**HISTORIC PRESERVATION REVIEW BOARD  
STAFF REPORT AND RECOMMENDATION**

Property Address:	<b>1421 Corcoran Street, NW</b>	<b>X</b>	Agenda
Landmark/District:	<b>14<sup>th</sup> Street Historic District</b>		Consent Calendar
Meeting Date:	<b>December 5, 2019</b>	<b>X</b>	Concept Review
H.P.A. Number:	<b>19-606</b>		Alteration
Staff Reviewer:	<b>Steve Callcott</b>	<b>X</b>	New Construction
			Demolition
			Subdivision

Audrey Elkins, representing owner Bashir Halabi, seeks conceptual design review for construction of a three-story row house in the 14<sup>th</sup> Street Historic District.

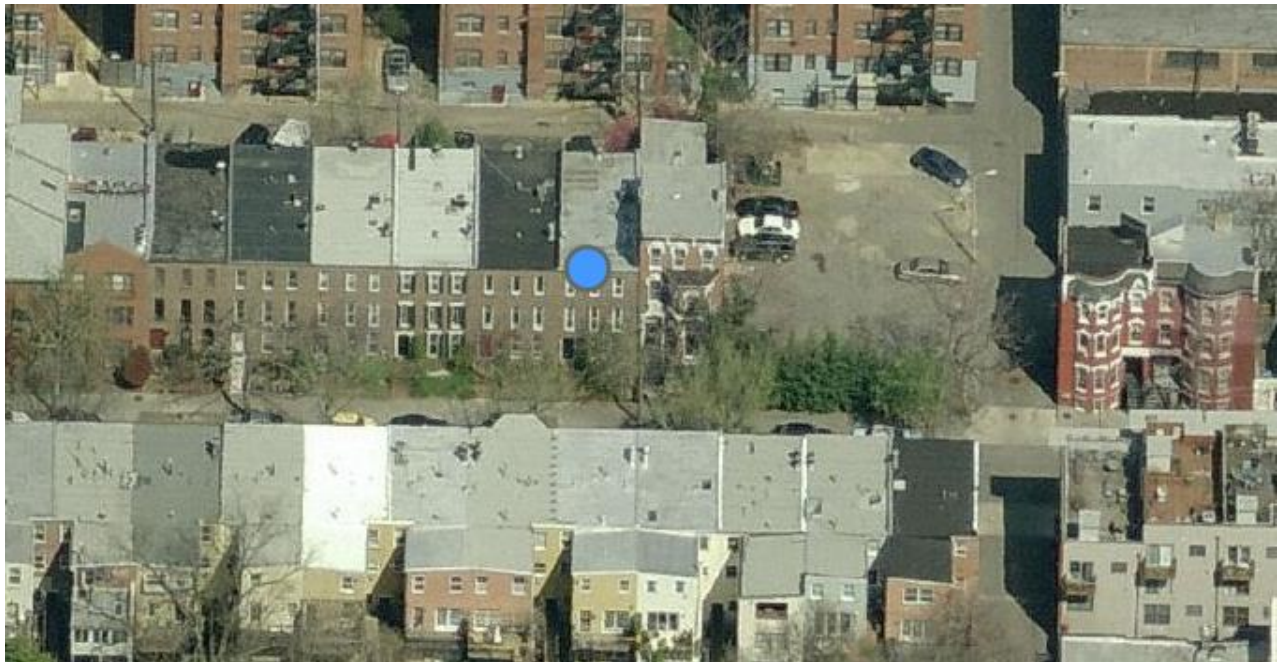
The Board approved a three-story-above-raised-basement house for this property in 2015, of a different design by a different architect. As with that proposal, the concept's three-story height, the alignment of the façade in both height and plane with the adjoining buildings, its orientation to the street, and the conceptual façade composition of three vertical bays of openings are all compatible with the character of the historic district and specifically consistent with the character of this streetscape.

What is unusual and not entirely resolved in the design is the open deck on the third floor and the requirement that the new construction be pulled back from the neighbor's chimney. The solution of expressing the open deck as an enclosed balcony (which was suggested by the HPO) works sufficiently well in elevation but, as there will be no side wall, it will be evident that this is merely a two-dimensional false front when seen in perspective above the neighboring house. As an alternative, it may be preferable to simply terminate the façade at the top of the second floor and set the third floor back rather than trying to incorporate it into the front façade.

*The HPO recommends that the Review Board approve the demolition of the existing building as non-contributing to the 14<sup>th</sup> Street Historic District, and seeks the Board's recommendation on whether the existing proposal is compatible or whether an alternative design should be pursued.*
